Ship's Name S.S. "KILWA"

Official No. 146136

Memorandum of alterations reported since ship was surveyed for assignment of Load Lines in 1947.

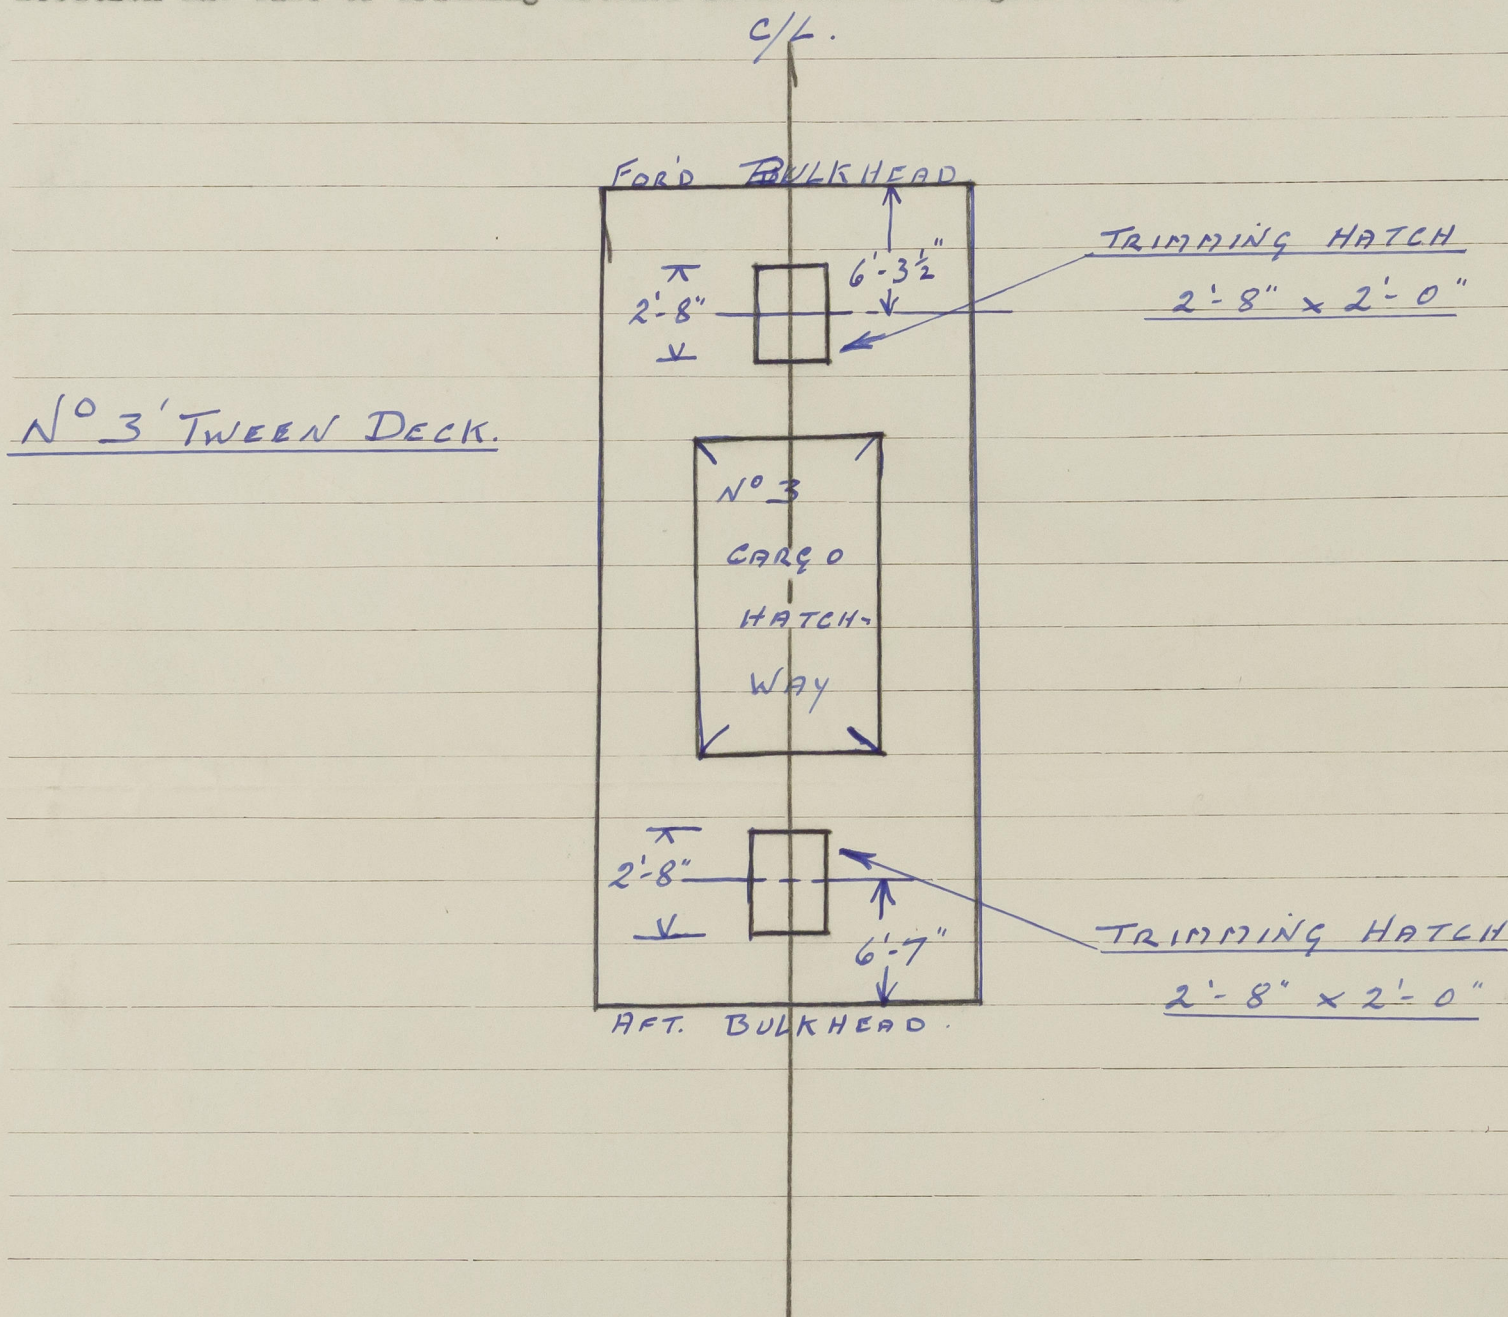
Two trimming hatches have been fitted in No. 3 Tween Deck.

These openings are provided with substantial wood coamings bolted to the deck beams.

Height of coamings above the deck beams 3".

Hinged wood covers with locking bars are provided.

Location and size of Trimming Hatches indicated on diagram below.
